CITY OF PORTLAND, MAINE

Project Name: **Portland Technology Park:**
a. **Amendment to Subdivision Plat (ID # 2015-172)**
b. **Site Plan for Patrons Oxford Insurance Office Building, LCE#4 (ID #2015-171)**
Address: Rand Road
(in 2015 the drive was given the E911 name of Technology Park Drive; LCE#4 is known henceforth as 97 Technology Park Drive)
CBL: CBL: 249-A-001-001
Applicants: a. Amendment to Subdivision Plat: City of Portland
b. Site Plan for Patrons Oxford Building on LCE#4: Patrons Oxford Insurance Co.
Planner: Jean Fraser

Subject: PTP Design Review – Patrons Oxford

PORTLAND TECHNOLOGY PARK AMENDMENT TO SUBDIVISION PLAT AND DEVELOPMENT OF LCE (LOT) #4 FOR OFFICES

The final site plan (Plan P14) is extracted below (the bubbles denote changes from the preliminary site plan):

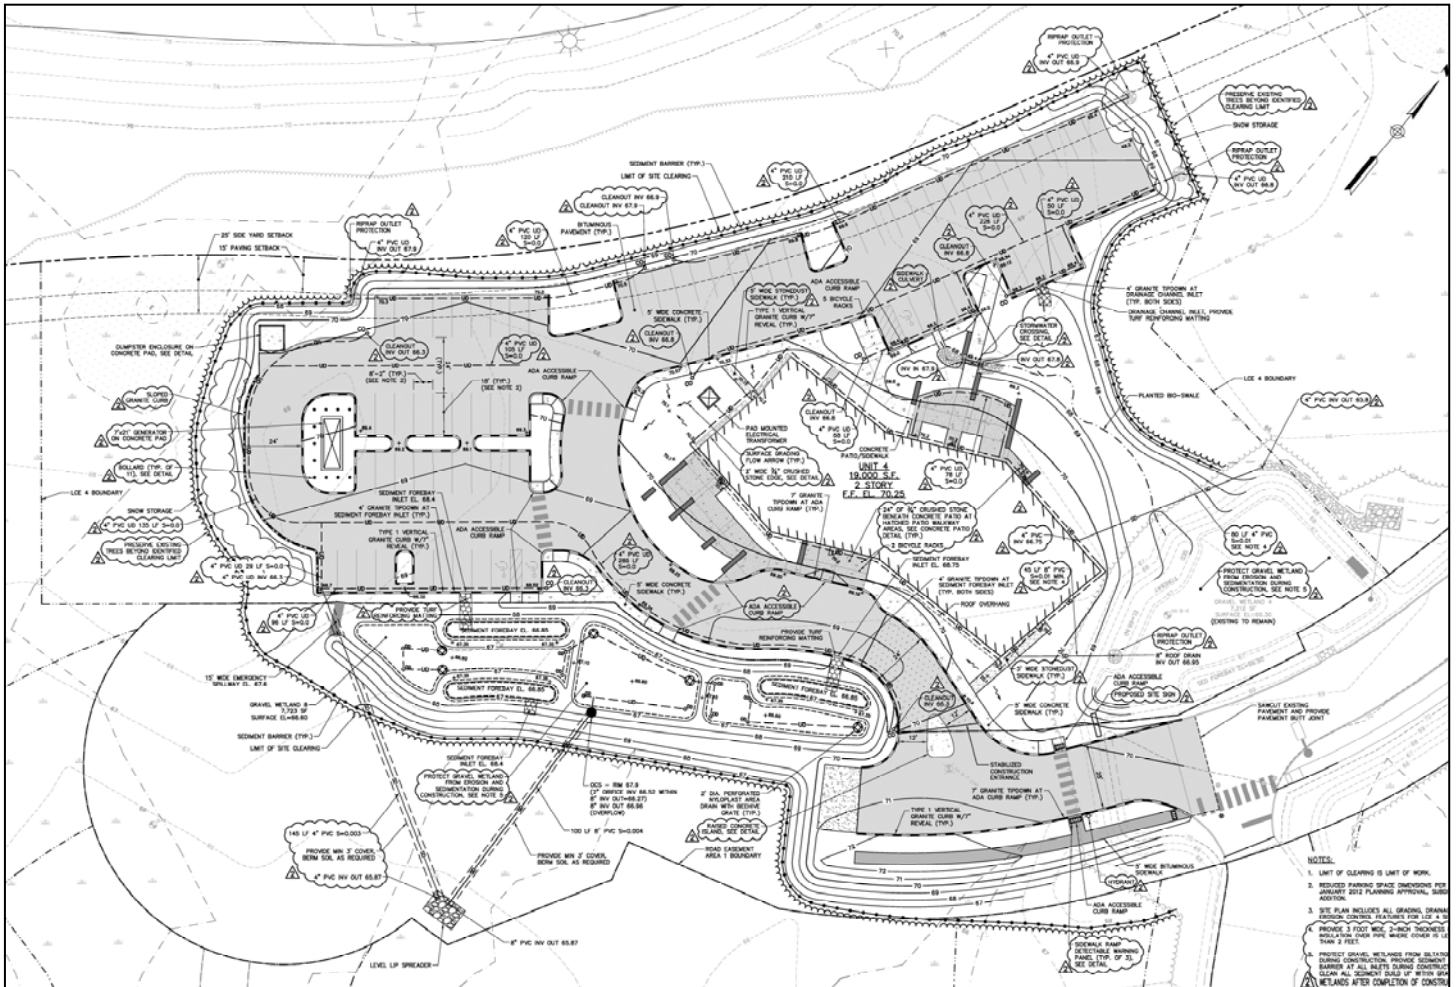
Since the PB Workshop a large generator has been added to the site plan and has posed a challenge due to its scale and anticipated noise levels.

The applicant has submitted Planting and Material Plans (Plans P30 to P33) which have been reviewed by the City Arborist, Jeff Tarling. Mr. Tarling’s comments on the preliminary proposals was very complementary (Attachment 5), but since then a large generator has been located within the largest parking island (resulting in the loss of four trees) with only bollards around it and no screening or planting.

Staff understand from the applicant’s consultants that there are no other suitable locations for the generator because the associated sound levels mean it must not be near a boundary nor near the building. Although the generator is at the most distant part of the site from the drive entrance, its appearance and location effectively undermine the site plan objective of requiring landscaped islands in parking areas.

Staff have suggested a number of ways that the generator could be slightly relocated on a larger island with greater screening, but there has not been time to fully explore and review the options. Staff suggest a condition of approval that allows time for further discussion at staff level to agree a revised approach. The Board may wish to provide direction to staff on this issue.

- a. To relocate and provide enhanced planting around the proposed generator to achieve a landscaped parking island that integrates with the overall landscape and provides screening from both local and distant viewpoints; and
